DELEGATED APPLICATION REPORT

App Ref: PL/25/1775 Householder planning permission

Address: 41 PATRICK ROAD, CAVERSHAM, READING, RG4 8DD

Proposal: Proposed part single storey and part two storey rear extensions. Front extension. Garage conversion. Two rear dormers and three front rooflights. (amended)

Fig 3: Existing and proposed floor plans and elevations

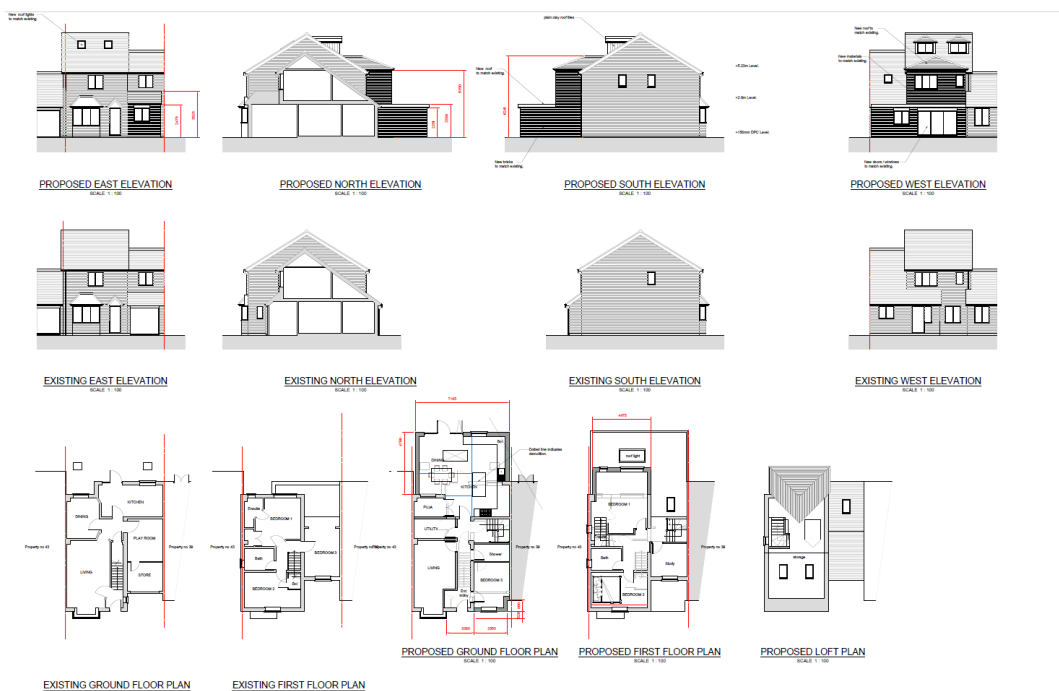
- 1) Loss of light: The originally proposed single-storey rear extension would have extended beyond the 60-degree line taken from the centre of the neighbouring property's habitable-room window. This would have resulted in an unacceptable loss of light. A reduction in depth was therefore required.

- 2) Front porch: The originally proposed front porch projection was not acceptable, as it would have disrupted the established front building line along the street.

With respect to loss of light, the proposed single-storey rear extension would not exceed the 60-degree line taken from the centre of the closest habitable-room window at No. 43, though it would slightly exceed the guideline when taken from No. 39. However, this is not considered sufficient to warrant refusal in this instance, given the single-storey nature of the proposal and its modest scale. In relation to the first-floor element, its depth is approximately 2m, and it partially sits on the existing rear cat-slide roof; therefore, no material loss of light to either adjoining property is anticipated.

Subsequently, revised plans were submitted to address the above matters. See the plans/documents considered section.
